**RESPONSES TO USEPA AND OEPA COMMENTS - OPERABLE UNIT 2
DRAFT FEASIBILITY STUDY - VOLUME 1 - NOVEMBER 1994 -
DRAFT**

**FERNALD ENVIRONMENTAL
MANAGEMENT PROJECT**

**RESPONSE TO USEPA AND
OHIO EPA COMMENTS
OU2 DRAFT
FEASIBILITY STUDY REPORT**

November 1994

FIGURE E.3.1-4
TYPICAL SECTIONS
OPERABLE UNIT 2
ON-SITE DISPOSAL CELL

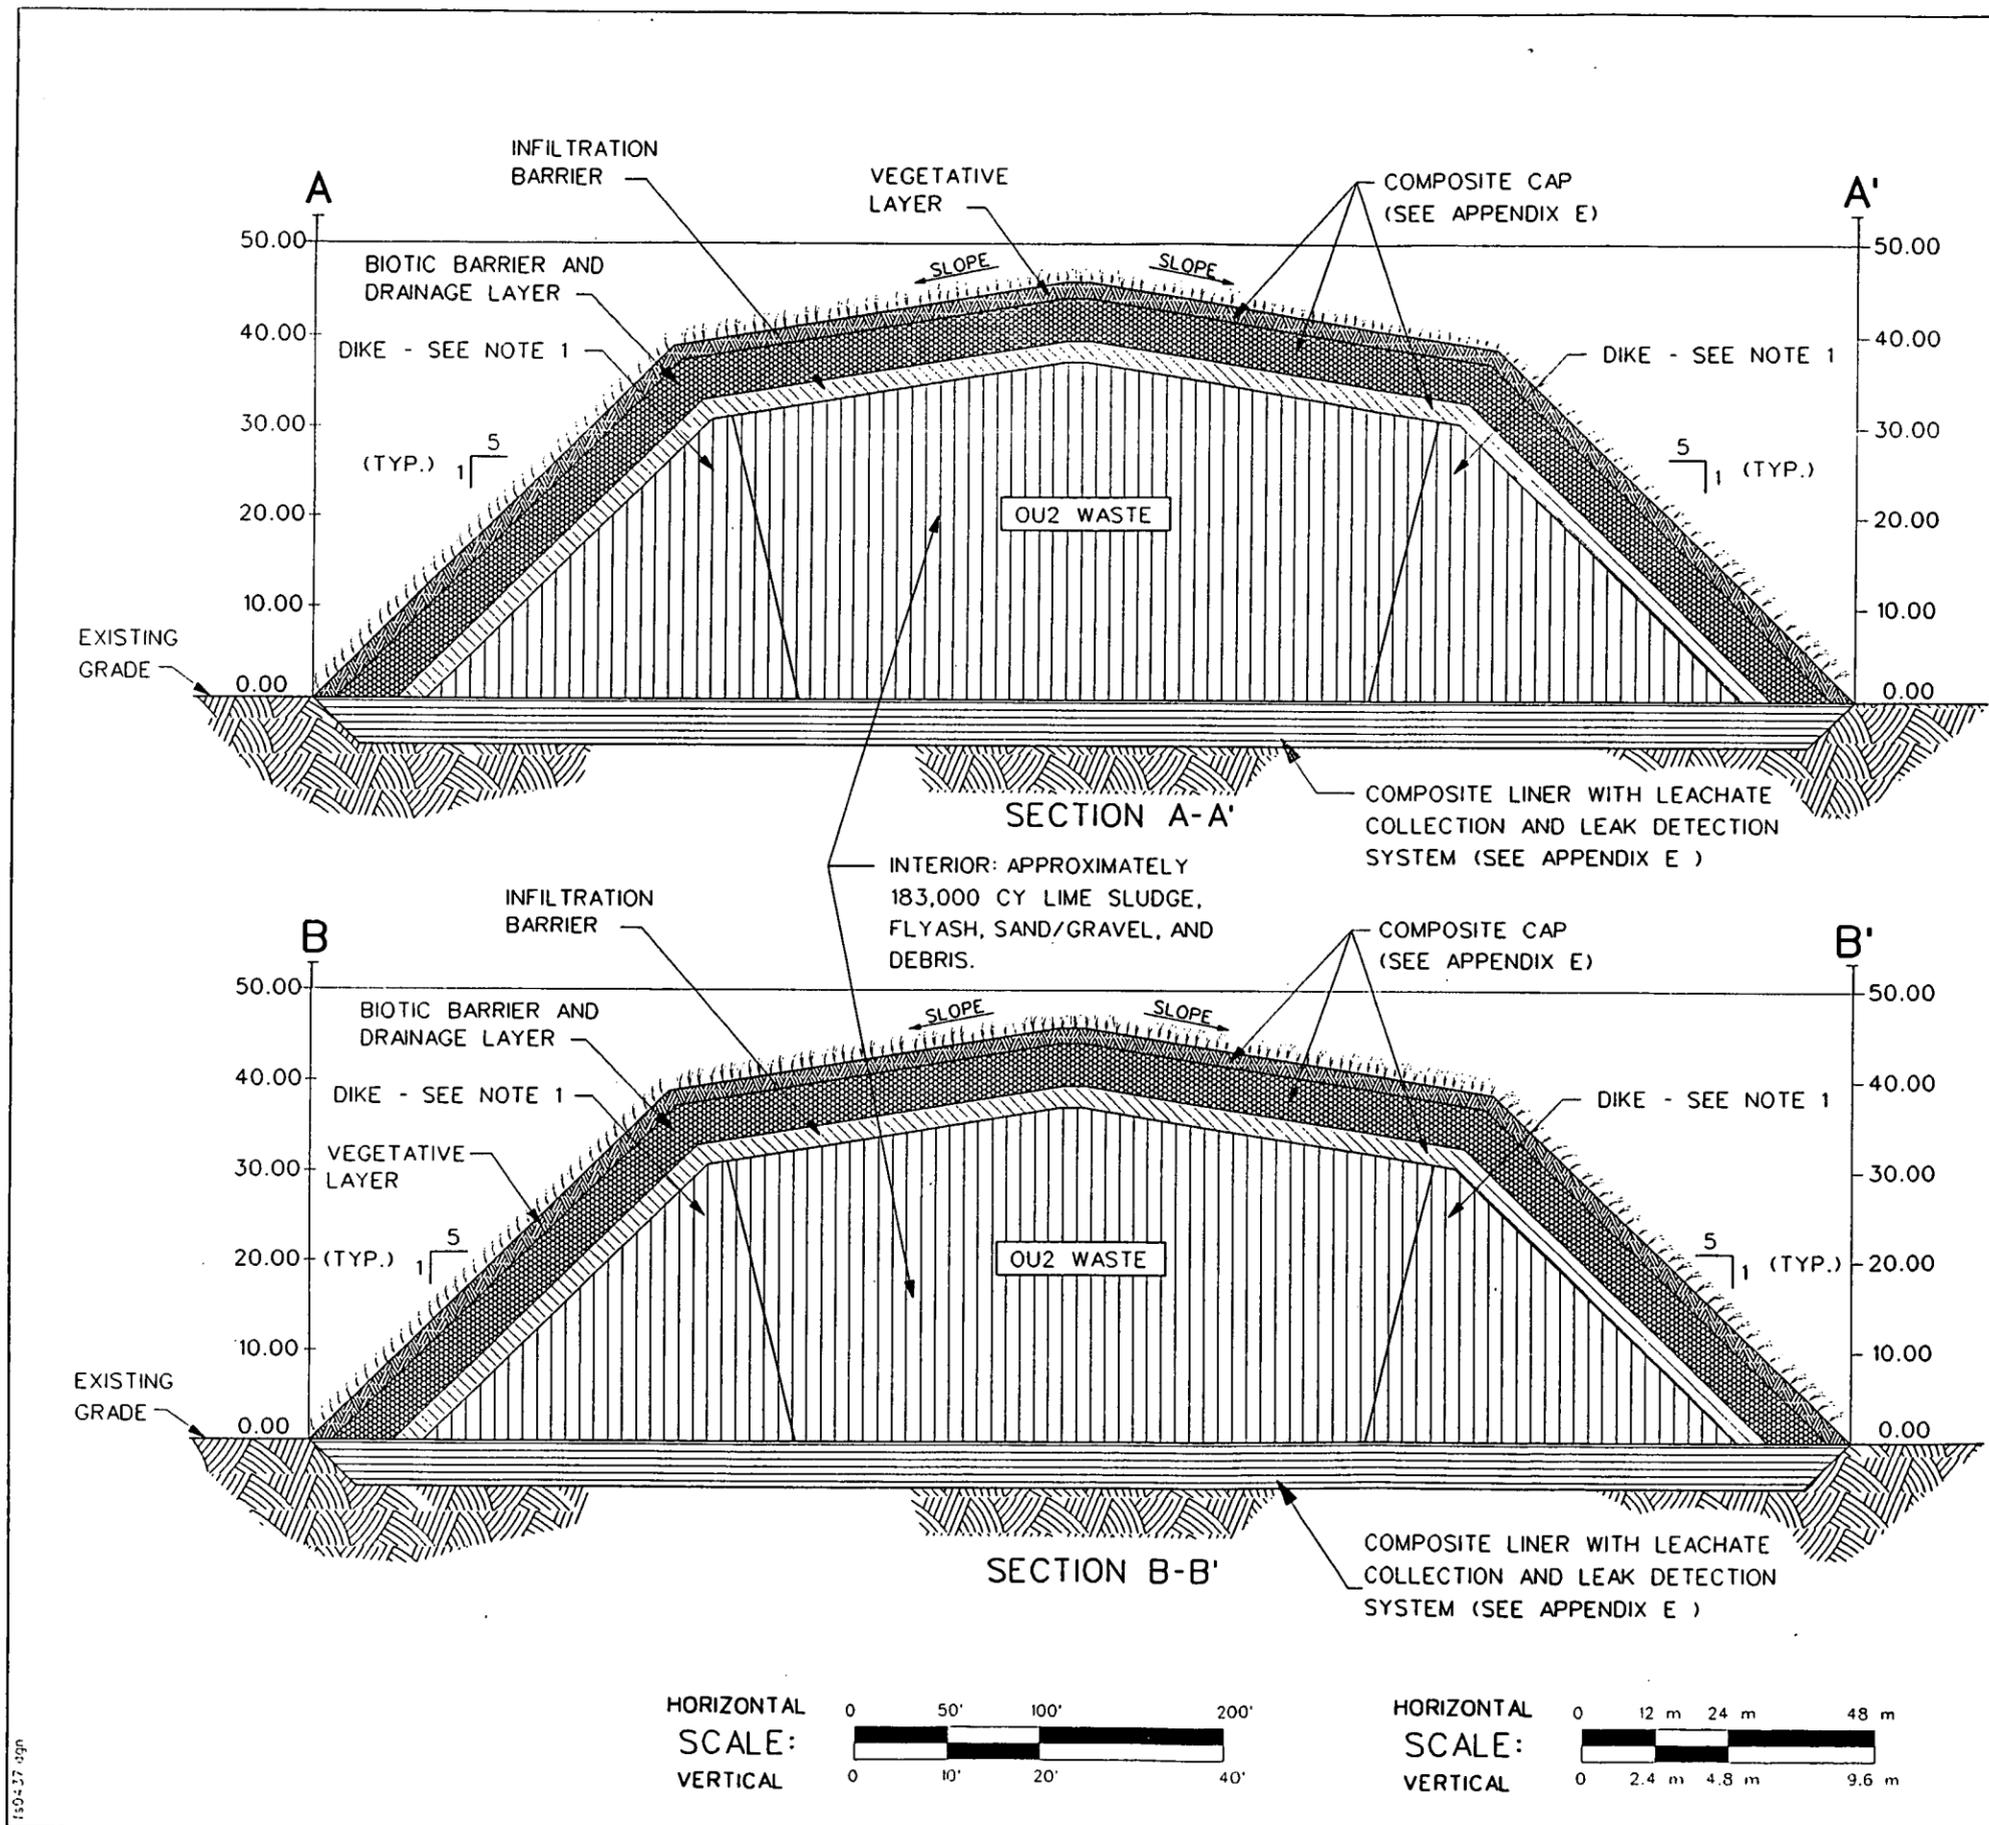
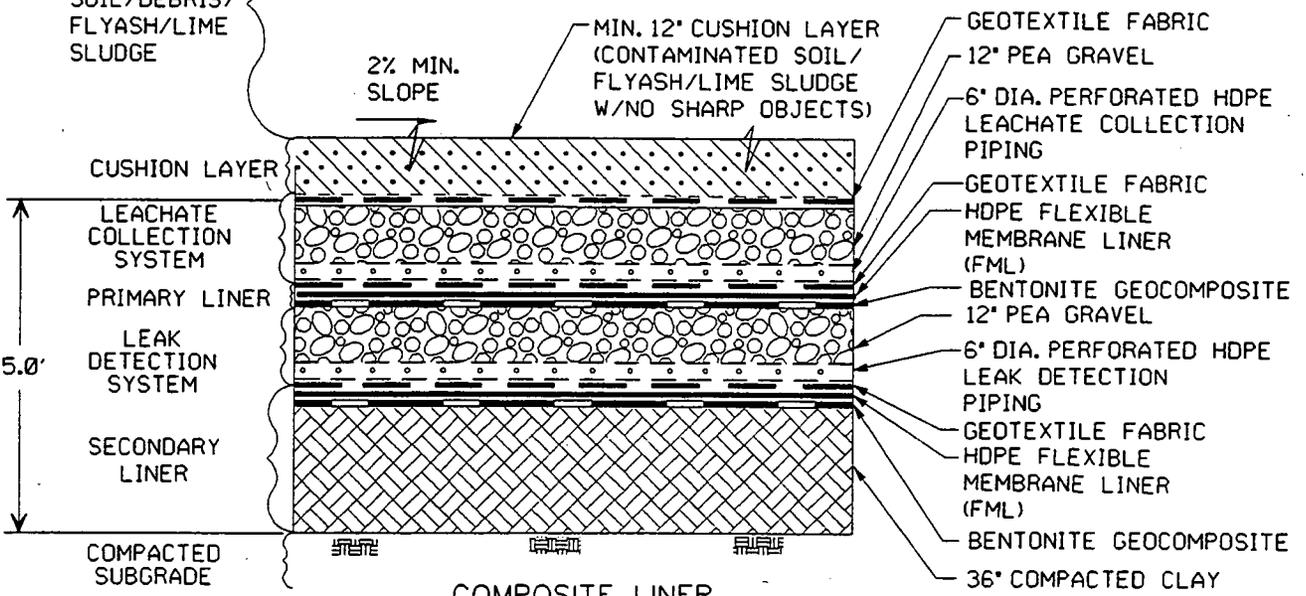
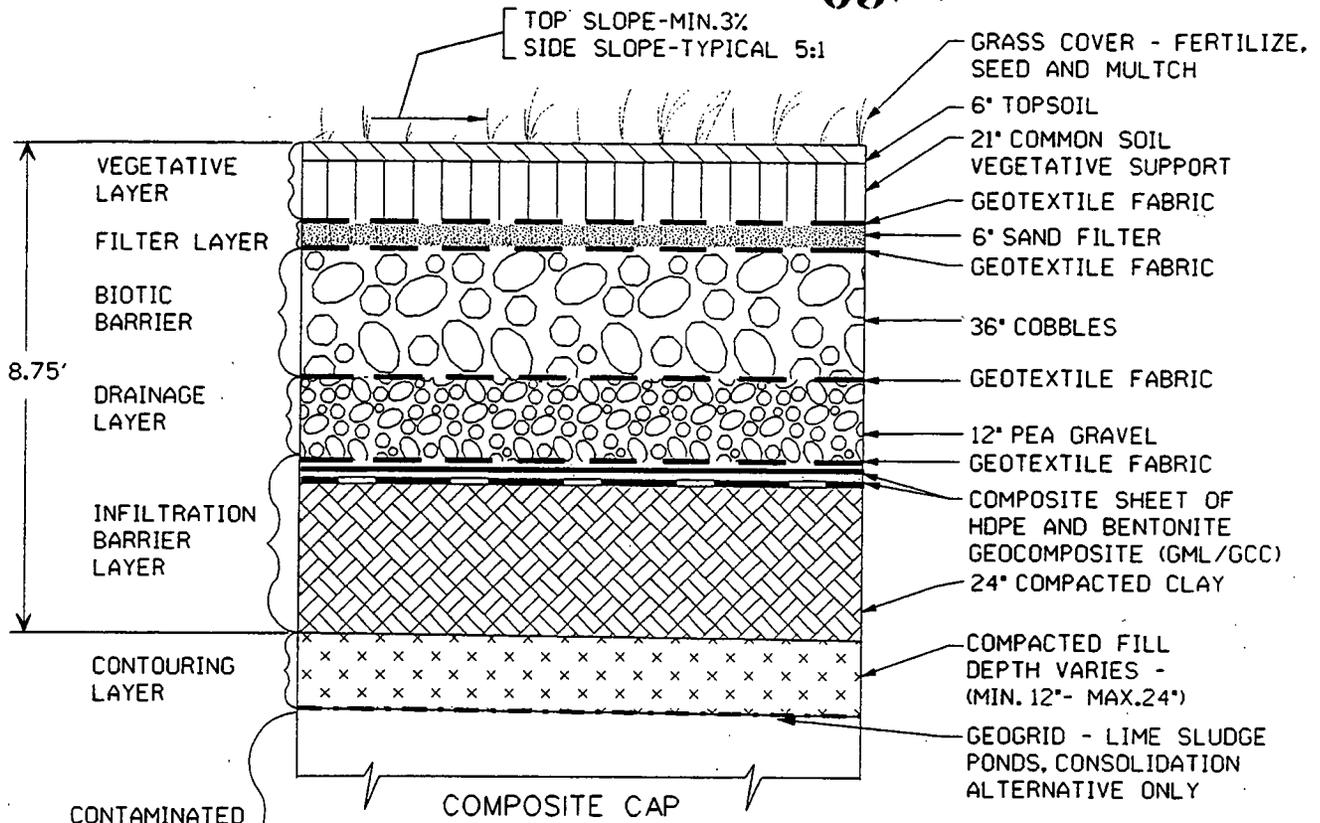
Commenting Organization: Ohio EPA Commentor: OFFO
 Section #: Fig. E.3-1-4 Page #: E.3-1-8 Line #: C Code: C
 Original Comment #:

Pages E-3-1-7, E-3-1-8, and E-3-1-10; Figures E.3.1-3, E.3.1-4, and E.3.1-6, respectively: Corrected these figures based on revised cap design and size of disposal cell.

FIGURE E.6-6
TYPICAL DETAIL
COMPOSITE CAP AND LINER
(NOT TO SCALE)

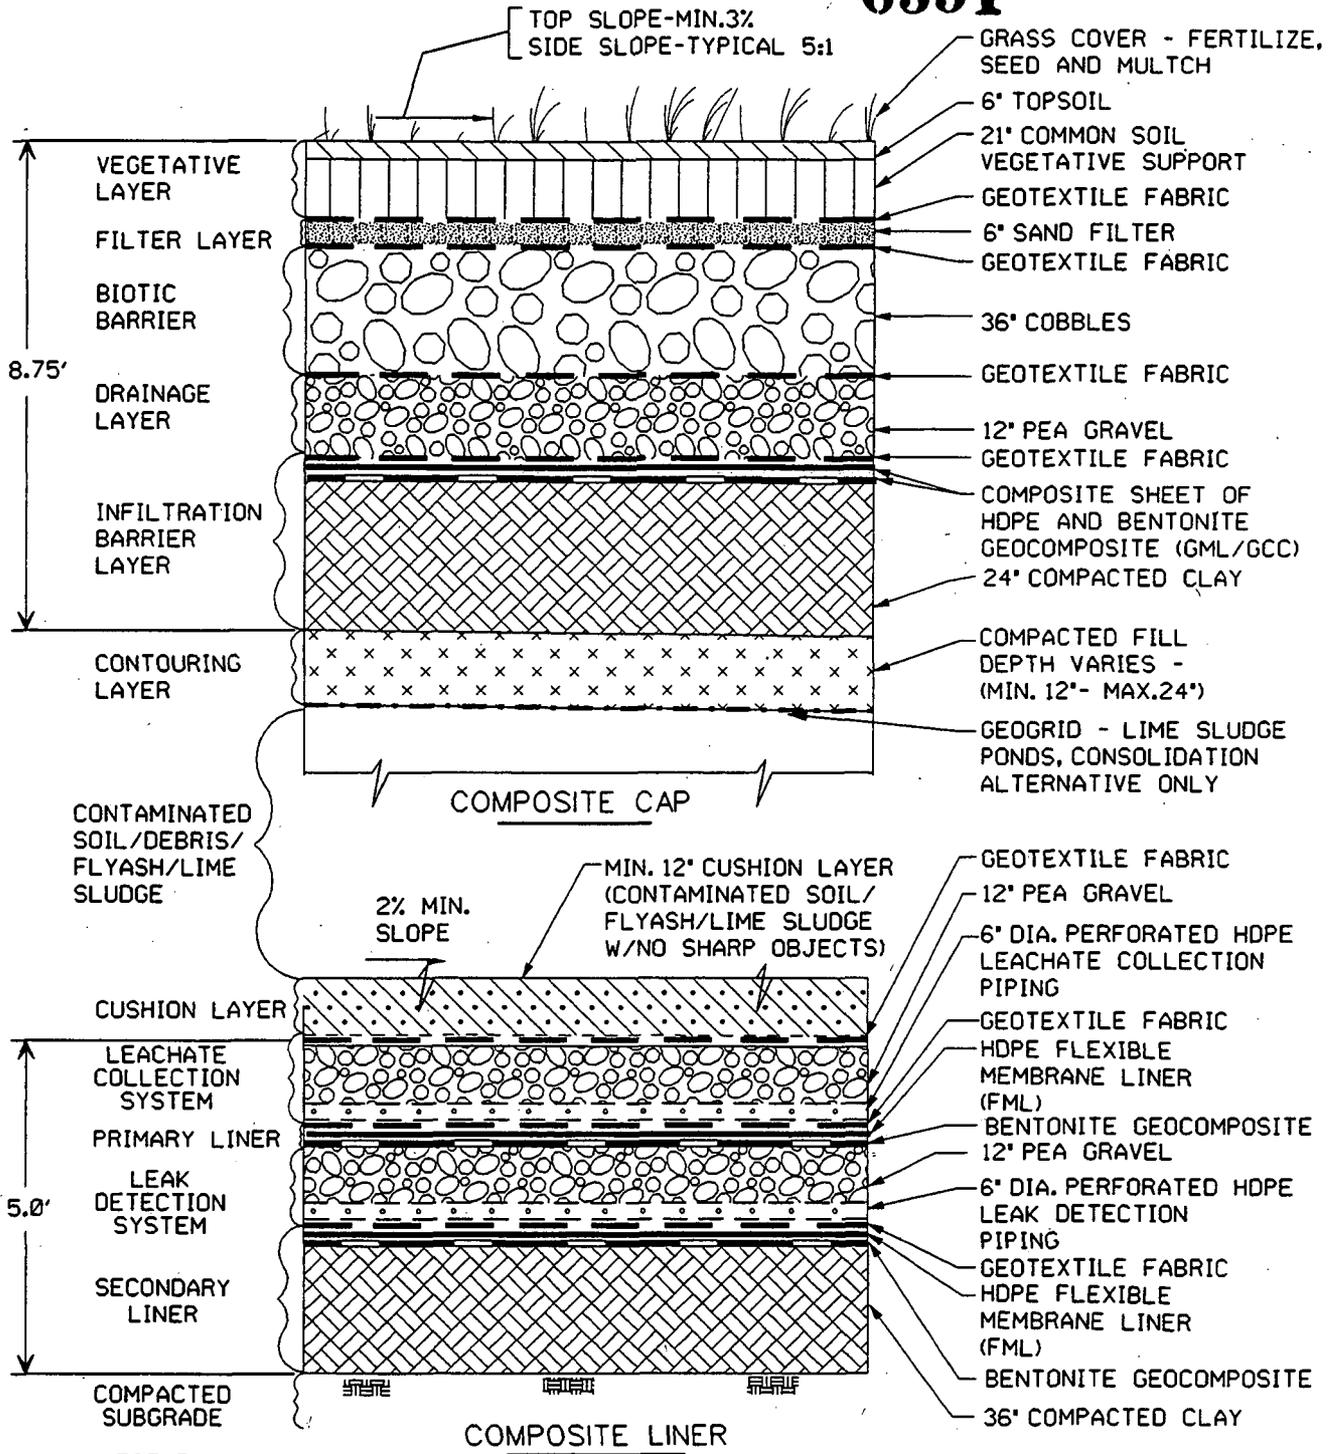
Comment: Ohio EPA has expressed concerns during previous meetings regarding infiltration through the side slopes where the composite cap does not extend. DOE should revise the design to extend the cap over these berms. In order to comply with Ohio EPA solid waste disposal facility design requirements the synthetic liner and cap should meet at the edges of the cell.

Page E-6-6, Figure E.6-6: Corrected slope for cap surface based on the revised cap design and added cap and liner thicknesses.
